J PUBLIC
COORDINATION

14 CFR
PART 150
UPDATE

Public Coordination Appendix Note: This appendix includes presentations and information provided for public coordination related to the San Diego International Airport Part 150 Study. Contents include presentations to the Airport Noise Advisory Council (ANAC), Citizens Advisory Committee (CAC), Technical Advisory Committee (TAC), public workshop presentations, and responses to comments on the content of the Part 150 Study document.

Fig. 4.

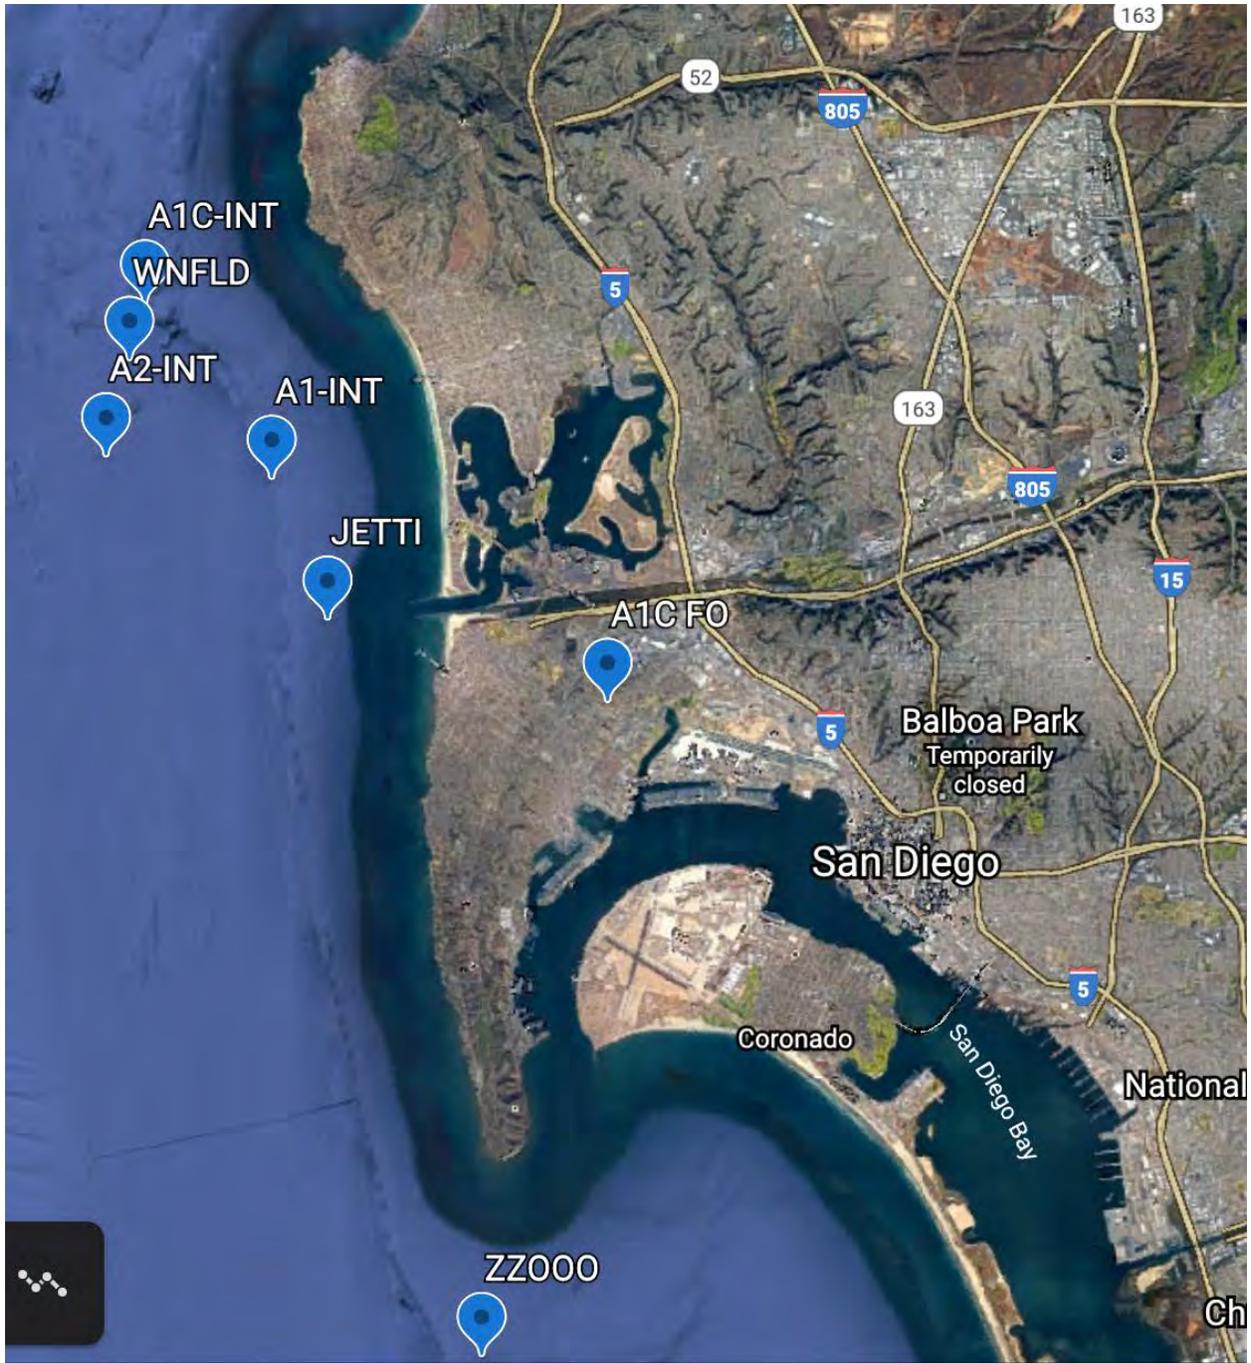
We note the consultants observation that “we can put the waypoints anywhere you want within reason” and we, therefore, would urge the consultants to anchor their designs and modeling on this central principle: use waypoints that are furthest west offshore as possible, measured from the center of the Mission Bay Jetty, routing planes as far away from our coastlines as possible. For clarification purposes, the coordinates for the suggested A2 INT waypoint should be placed as far west of the shoreline, and as far south of the WNFLD waypoint, as possible. The following Fig. 4 was created based on coordinate data provided by
